Office Action Summary

09/830,388

COLLIER ET AL.

DETAILED ACTION

OFFSHORE DRILLING STRUCTURE

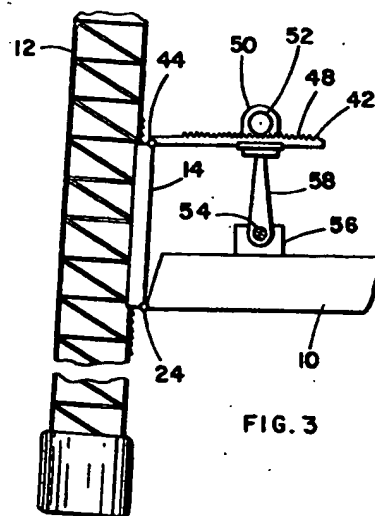
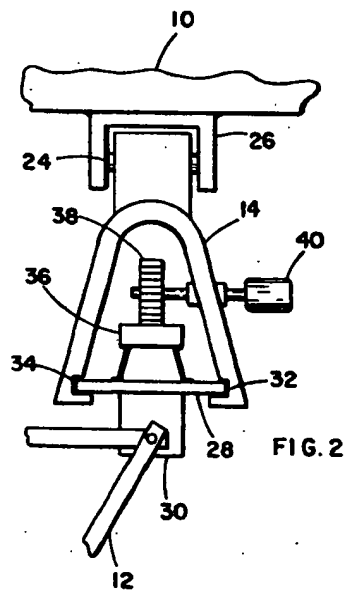
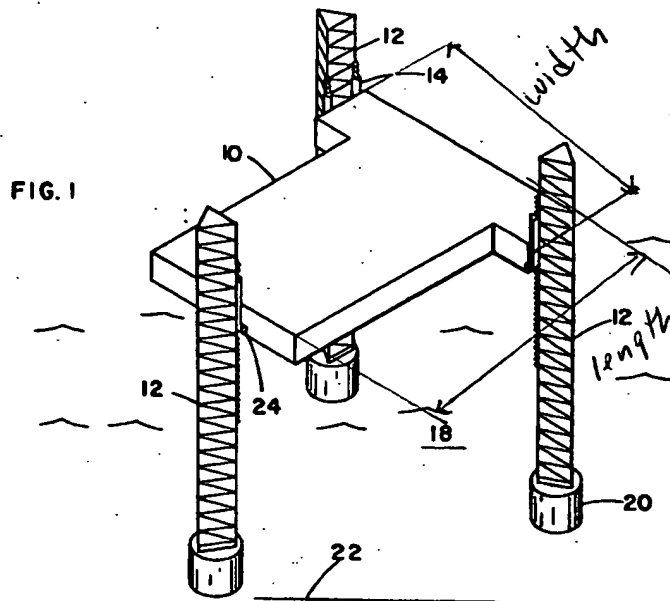
Blenkarn discloses an offshore structure comprising a base (20), a substantially rectangular deck (10) having a width and a length with the width being defined between two substantially parallel side edges (see attached marked up Figure 1 for interpretation of parallel side edges) and the length being defined between two additional side edges (see attached marked up Figure 1 for interpretation of the additional side edges), a plurality of legs (12) extending substantially perpendicular to their respective bases between the bases and the deck, wherein the plurality of legs are attached to their
